**SAFETY EVALUATION BY THE OFFICE OF NUCLEAR REACTOR REGULATION**  
**OF REQUEST FOR RELIEF NO. IR-28, FIRST 10-YEAR INTERVAL**  
**NORTHEAST NUCLEAR ENERGY COMPANY**  
**MILLSTONE NUCLEAR POWER STATION, UNIT NO. 3**  
**DOCKET NUMBER 50-423**

### 2.1 Request for Relief IR-28 - First Inspection Interval - Reactor Pressure Vessel Supports

Figure 1  
Reactor Vessel Support Assembly

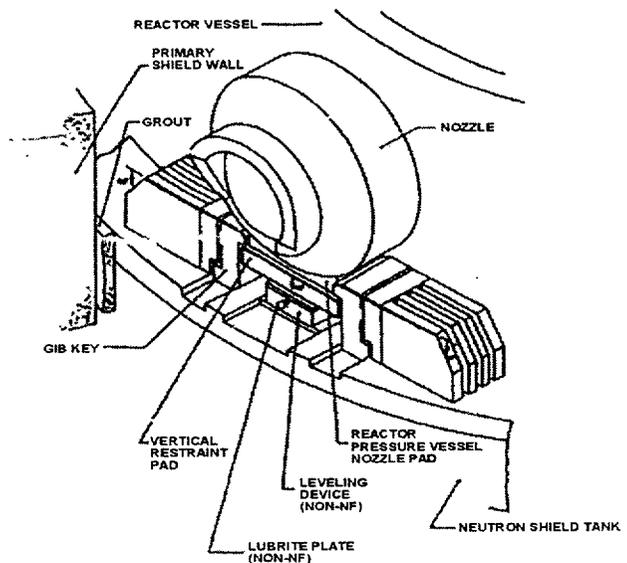
The Millstone Unit No. 3 reactor vessel has four supports that are located under two cold leg nozzles and two hot leg nozzles. The support assembly at each of these nozzles consists of a nozzle pad and steel plates positioned between a steel support structure that is welded to the neutron shield tank as shown in Figure 1. The support is designed to function as a vertical restraint, loaded in compression and would not

be subject to typical failure mechanisms associated with stress at rigid connections and loosened or degraded fasteners. The majority of each support is encased in the permanent insulation panels of the reactor vessel and vessel nozzles. Portions of the steel support structure and associated welds are accessible for a limited visual VT-3 examination.

When performing the examination during the last refueling outage (RFO6), NNECO determined that the supports are located in a congested, confined space below the permanent refueling cavity seal ring. The area can only be accessed through four seal ring hatches. In addition to difficult access, the radiation levels in the area are approximately 100mr - 150mr per hour. It is estimated that the removal and reinstallation of the permanent insulation in this confined space would result in additional exposure of approximately 4.0 man-rem. Additionally, it is anticipated that modification and/or removal of the permanent cavity seal ring would be required to support access for this project. Based on the access restrictions, high radiation levels and support design, relief is requested from performing the visual VT-3 examination on the inaccessible portions of these supports for Millstone Unit No. 3, first 10-year inspection interval (April 23, 1986 through October 23, 1999).

The Code requires that Class 1 supports, other than piping supports, be subject to a 100 percent VT-3 visual examination once every interval. However, due to access restrictions, the support design, and high local radiation levels, as an alternative during RFO6 the licensee performed a limited VT-3 visual examination on the accessible portions of the supports including examination of the insulation for any evidence of disturbance or degradation attributable to abnormal support disturbance. Because of the design of the support and the significant thermal loads experienced by the support during transitions between shutdown and operating conditions, it is reasonable to conclude that problems with the alignment or assembly of the supports would result in degradation of the insulation surrounding the supports. Also, portions of the steel structure and associated welds are visible for VT-3 visual examination. Examination of these areas provides further information regarding the condition of the supports. On the basis of the above considerations, the staff concludes that the licensee's proposed alternative examination provides reasonable assurance of continued structural integrity of the reactor pressure vessel supports.

The NRC staff has evaluated the licensee's submittal and concludes that pursuant to 10 CFR 50.55a(a)(6)(i) NNECO has demonstrated that performing the visual examination to the extent required by the Code of the reactor pressure vessel supports is impractical and that the alternative examination provides reasonable assurance of structural integrity. Therefore, relief

is granted and the alternative requirement imposed for the first 10-year inspection interval pursuant to 10 CFR 50.55a(g)(6)(i). The relief granted is authorized by law, will not endanger life or property or the common defense and security, and is otherwise in the public interest giving due consideration to the burden upon the licensee that could result if the requirements were imposed on the facility.
